### REMARKS

#### **Brief synopsis of changes to the claims:**

**Letters to the Draftsman:**

Fig. 3

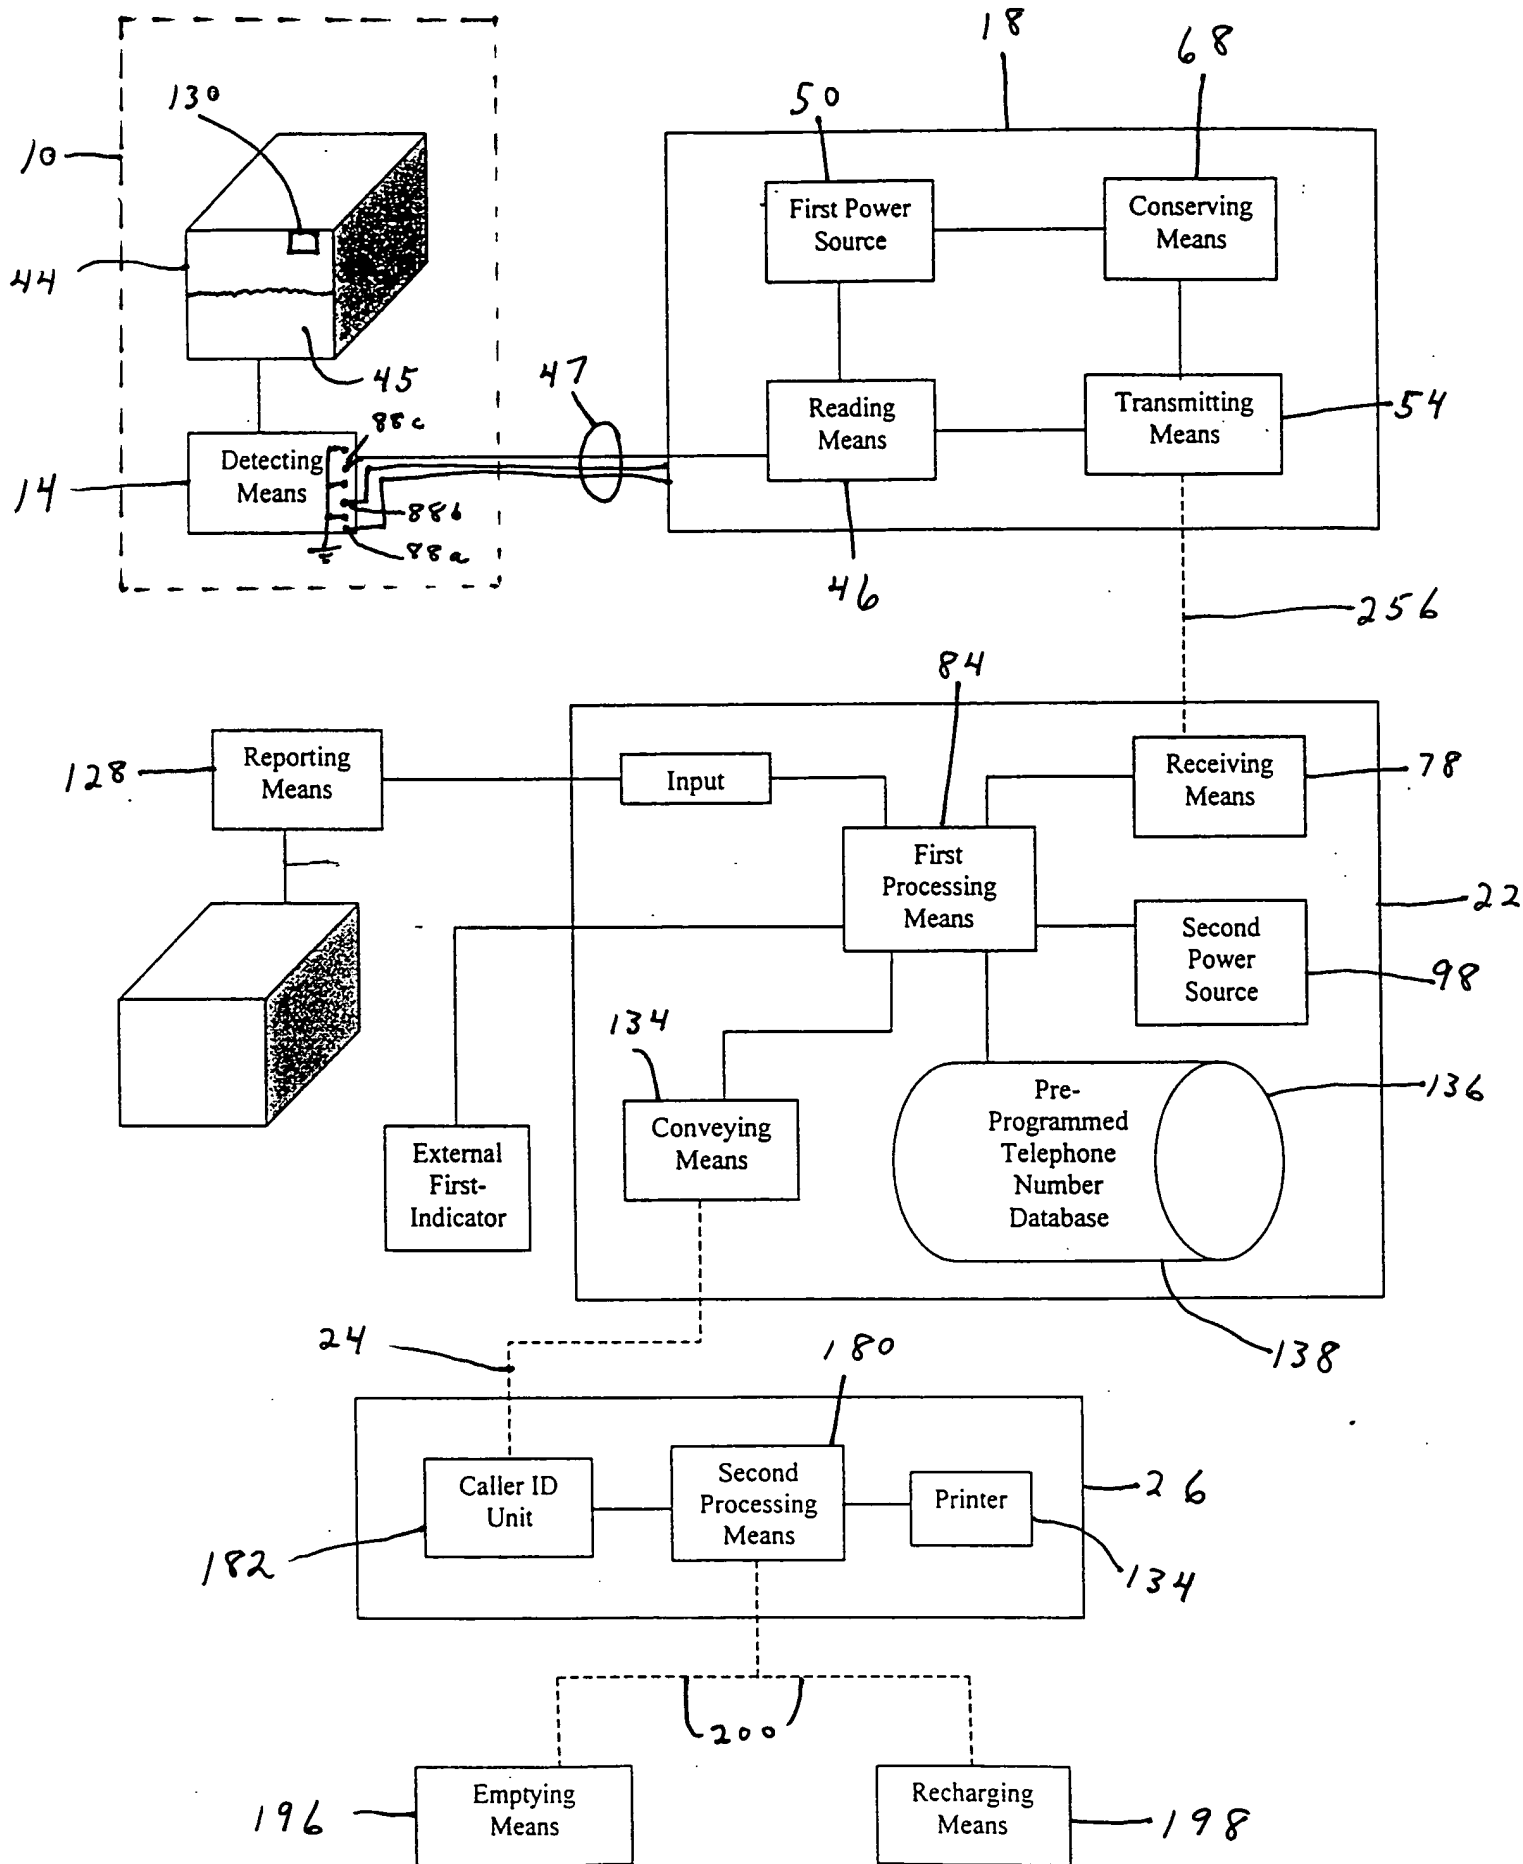
In particular, in the **first letter to the draftsman**, reference characters have been added to each of the drawings, and in figure 3, a representation of the material 45, line 47, contacts 88, and ranging unit 130 have each been added. These features are all clearly disclosed in the original specification and claims.

Fig 3A

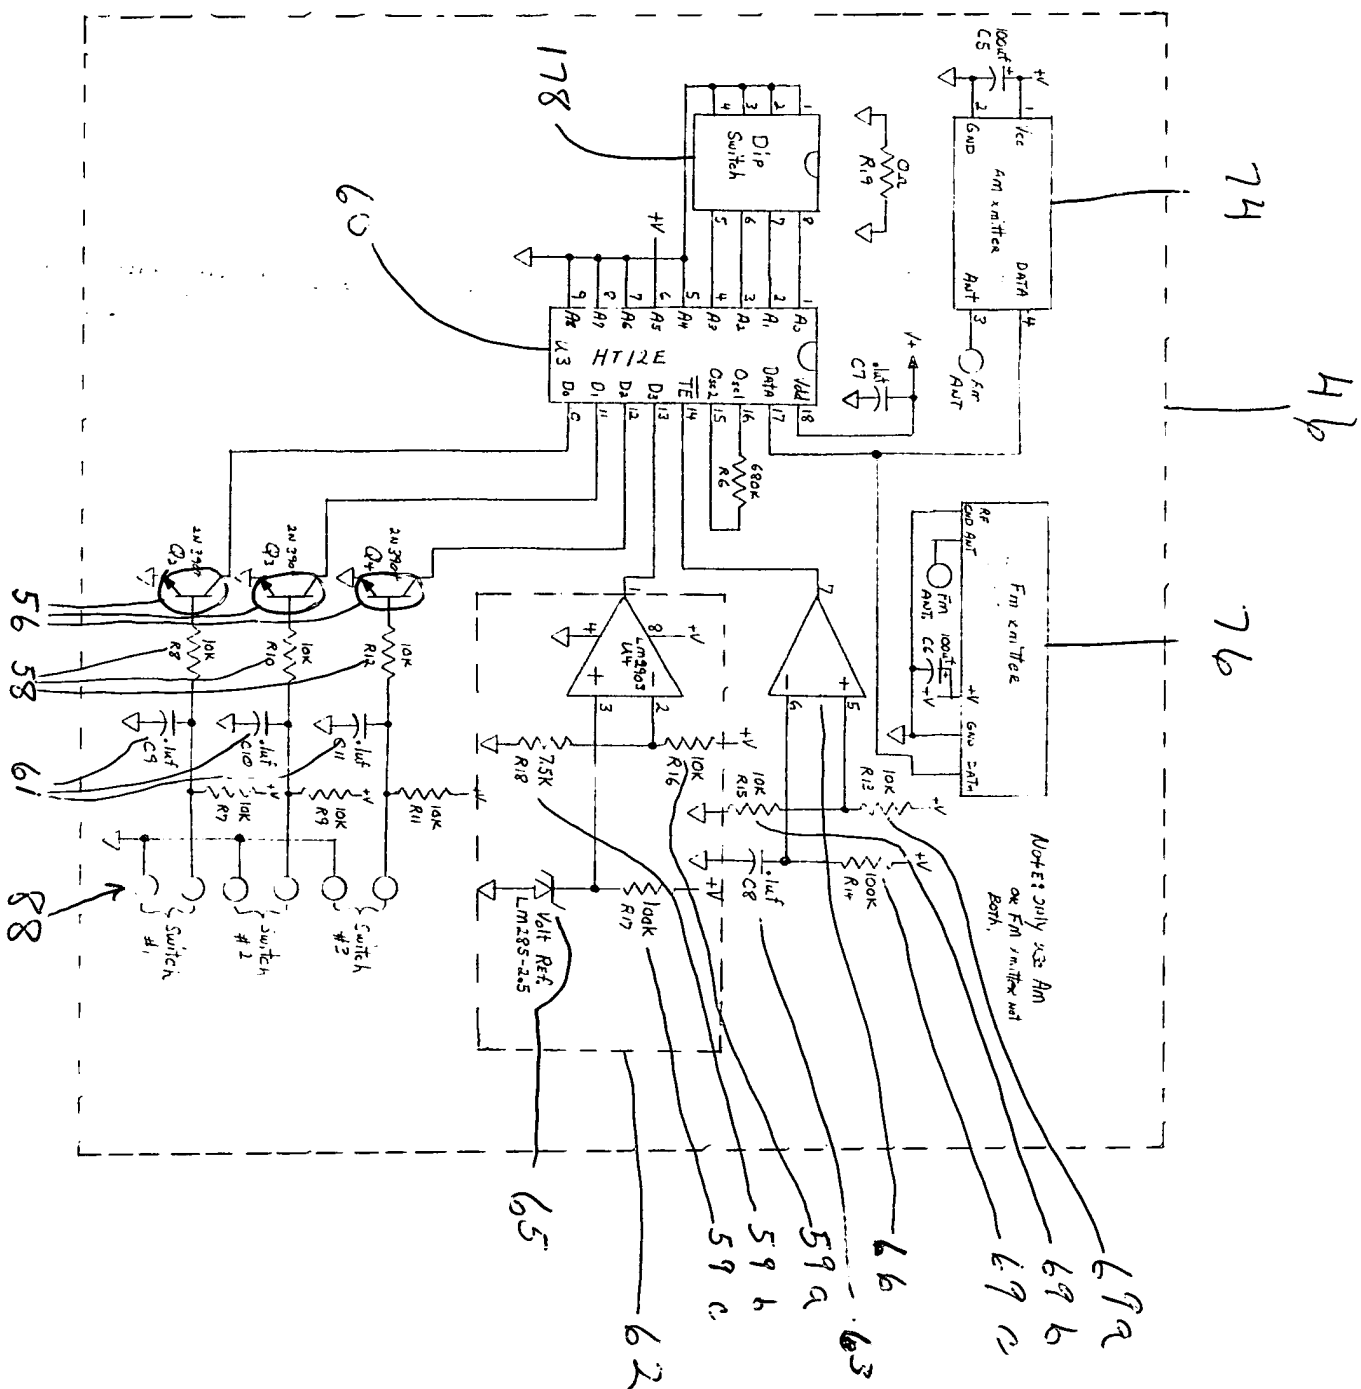
In a **second letter to the Draftsman**, two new drawings have been added, as figures 3A and 3B. Support for these new drawings can be found throughout the specification.

More especially for figure 3A, support is found in the original specification at page 11, line 3 through page 12, line 20. Support for figure 3A can also be found in original claims 17, 19, 20 and 21, and in the new, substitute specification at page 13, line 12 through page 16, line 11.

Fig 3B

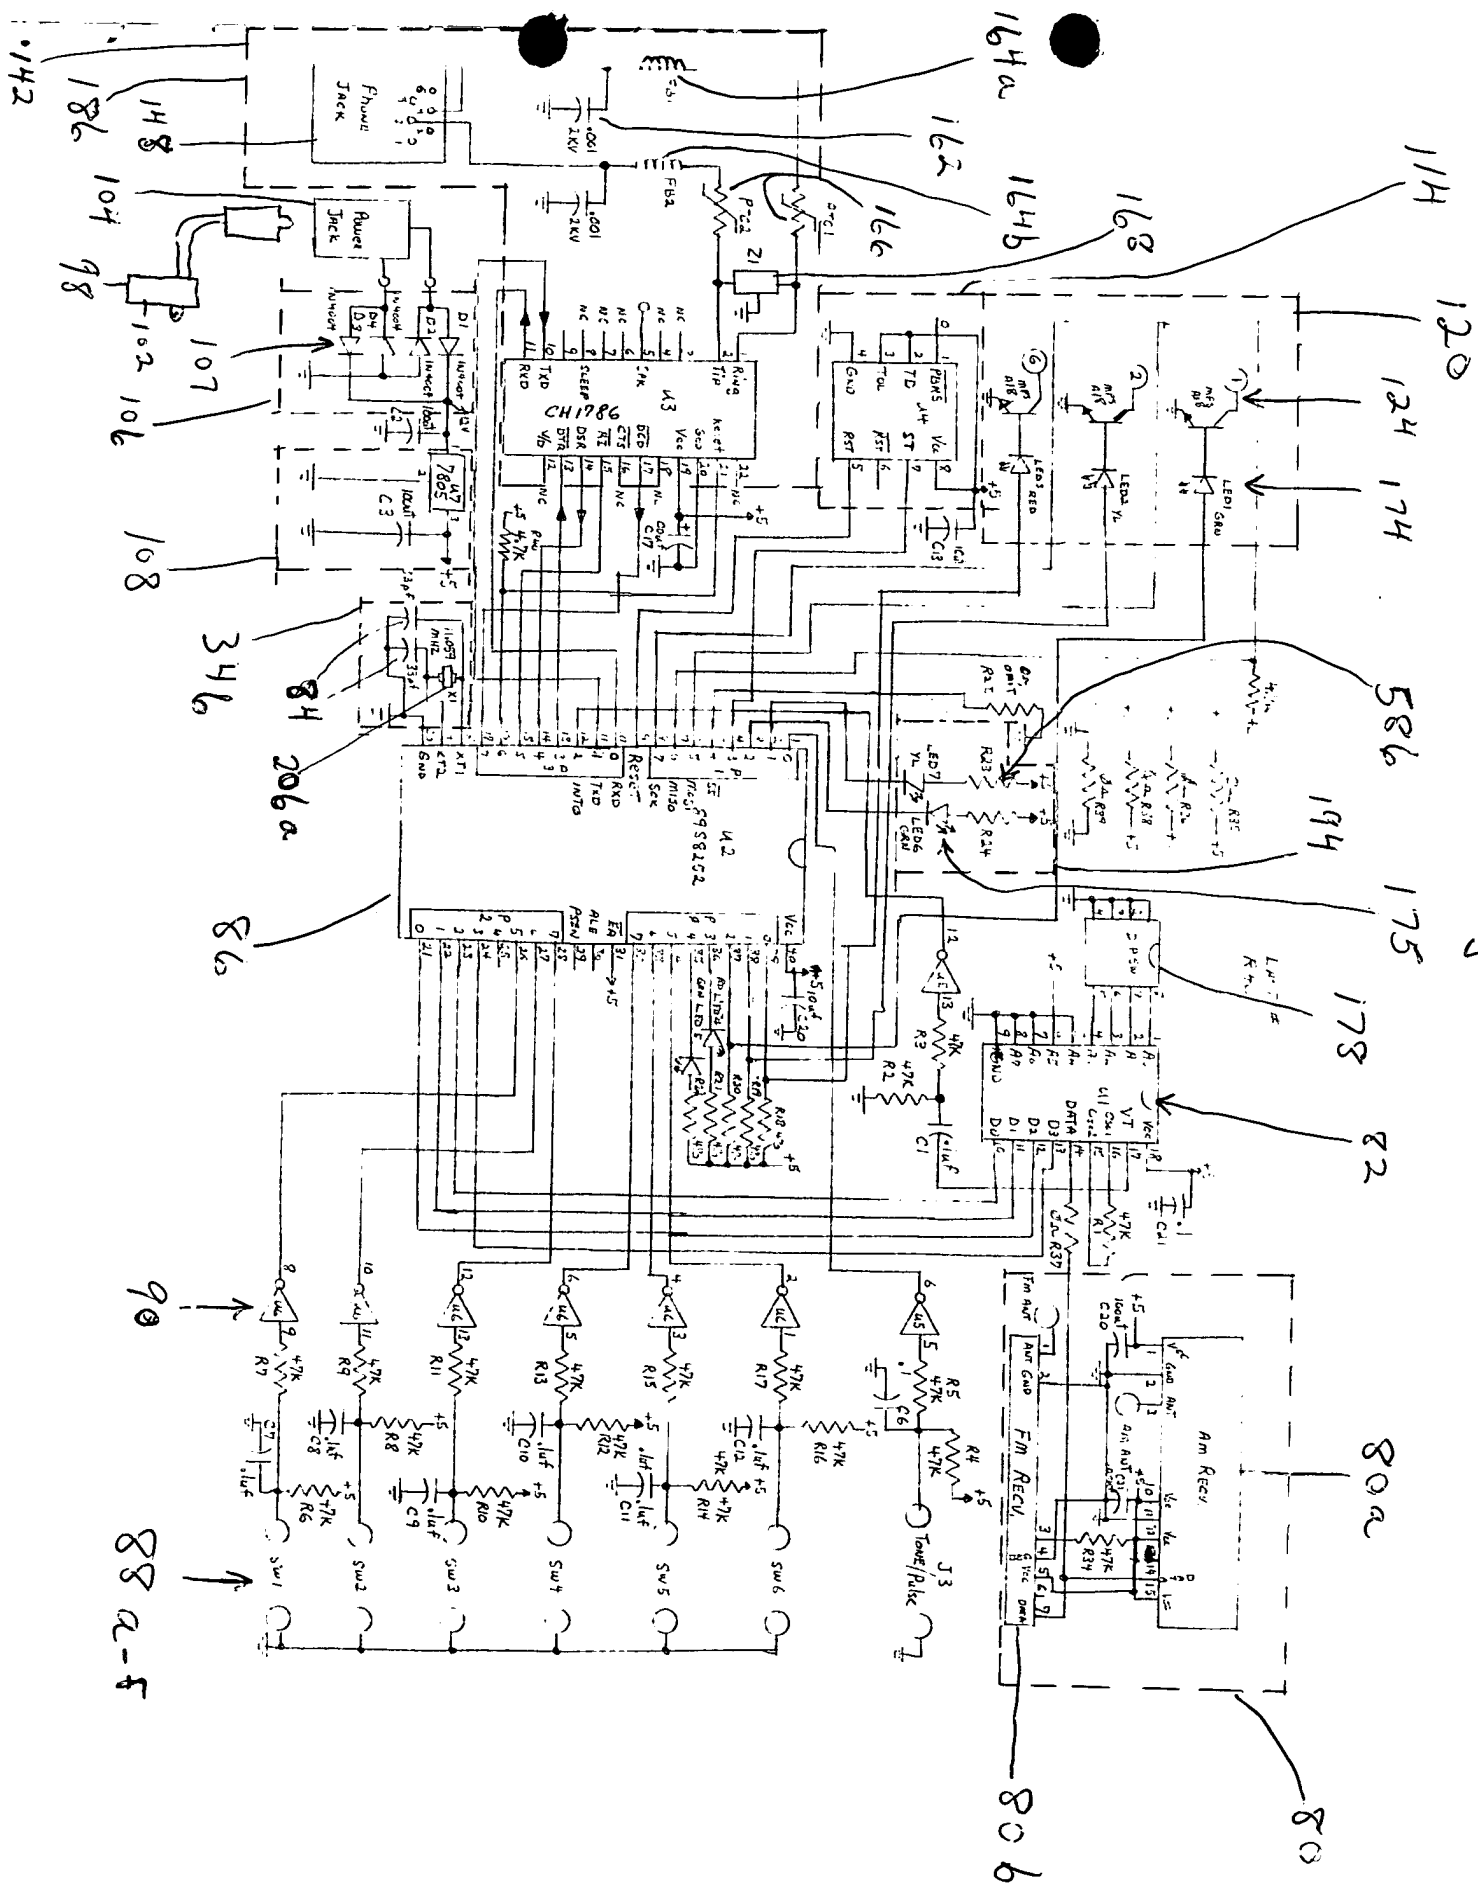
For figure 3B, support is most directly found in the original specification at page 13, line 1 through page 16, line 10, as well as in original claims 26-28, and 47-50, and also in the substitute specification at page 16, line 12 through page 22, line 22.
